ADDRESS: 135 S 18TH ST

Proposal: Install illuminated signage

Review Requested: Final Approval

PHILADELPHIA HISTORIC COMMISSION

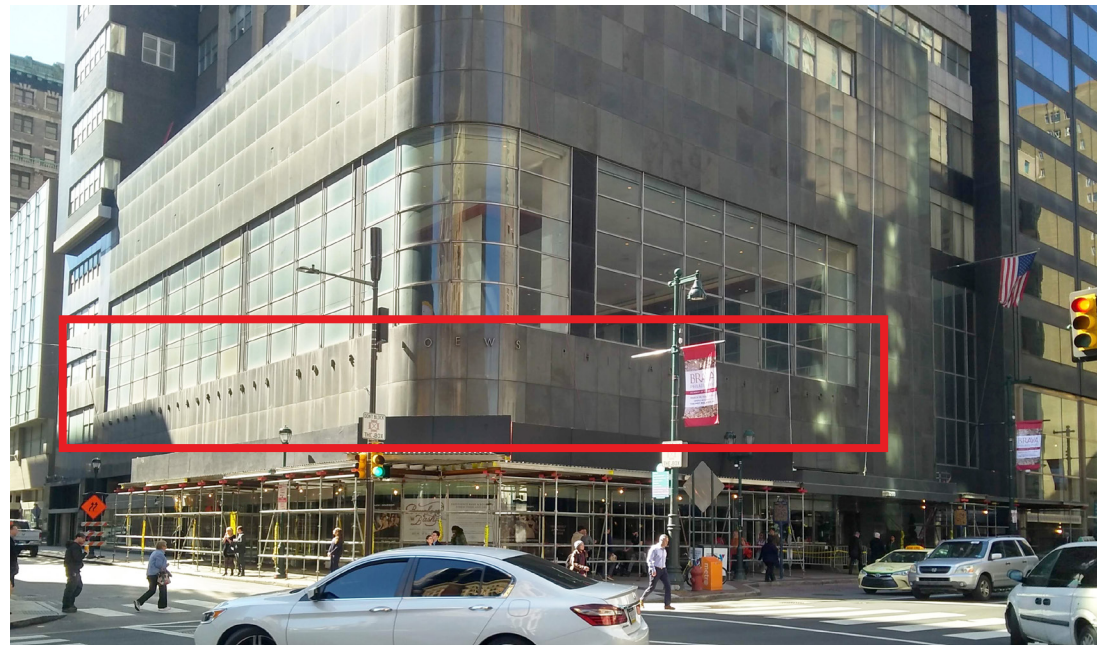
ALIGN CL OF
LETTER 'L' W/ CL
OF WINDOW

UPDATE 'aka'
LETTERING WITH 'abar'
SAME FONT, AREA,
LOCATION
